Access Compliance Report

Public Rights-of-Way

(Curb Ramps)

Intersection ID: 42923	Main Street: BRAY_DR	Cross Street: LIFFORD_DR	Location:	N
ADA ID: 1FEBDBCE8AAA	Ramp Type: PerpDiag	Initial Pass/Fail: Fail	Overall Compliance: No	Severity Score: 17.5
Codes/Mitigation Info/Possible Solution		Field Measurements/Component Compliance

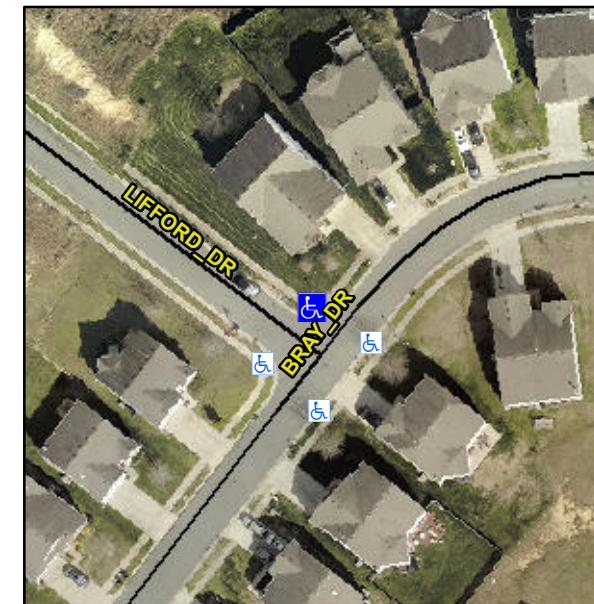
Not Found, R304.5.1

Compliance	Description	Data	Compliance	Description	Data
N/A	Ramp Length (in)	48.0	Yes	Ramp Slope (%)	6.0
No	Ramp Width (in)	32.0	Yes	Ramp XSlope (%)	0.9
N/A	Flare Type LT	N/A	N/A	Flare Type RT	N/A
N/A	Flare Slope LT (%)	N/A	N/A	Flare Slope RT (%)	N/A
N/A	Flare Traversable LT?	N/A	N/A	Flare Traversable RT?	N/A
N/A	Landing Length (in)	N/A	N/A	DWS Provided?	N/A
N/A	Landing Width (in)	N/A	N/A	DWS Contrast?	N/A
N/A	Landing Slope (%)	N/A	N/A	DWS Length (in)	N/A
N/A	Landing X Slope (%)	N/A	N/A	DWS Full Width?	N/A
N/A	Landing Curb? (Y/N)	N/A	N/A	DWS Offset (in)	N/A
N/A	Shared Landing?	N/A			
N/A	Gutter Ponding?	N/A	N/A	Gutter Slope (%)	N/A
N/A	Gutter Lip Ht (in)	N/A	N/A	Gutter X Slope (%)	N/A
N/A	Painted X Walk1?	No	N/A	Painted X Walk2?	No
	X Walk 1 Direction	To SW		X Walk 2 Direction	To SE
N/A	X Walk 1 Width (in)	N/A	N/A	X Walk 2 Width (in)	N/A
	X Walk 1 Slope (%)	2.7		X Walk 2 Slope (%)	2.4
	X Walk 1 X Slope (%)	1.8		X Walk 2 X Slope (%)	2.6

Remove & Replace Curb Ramp With Two New Directional Ramps or Equivalent.
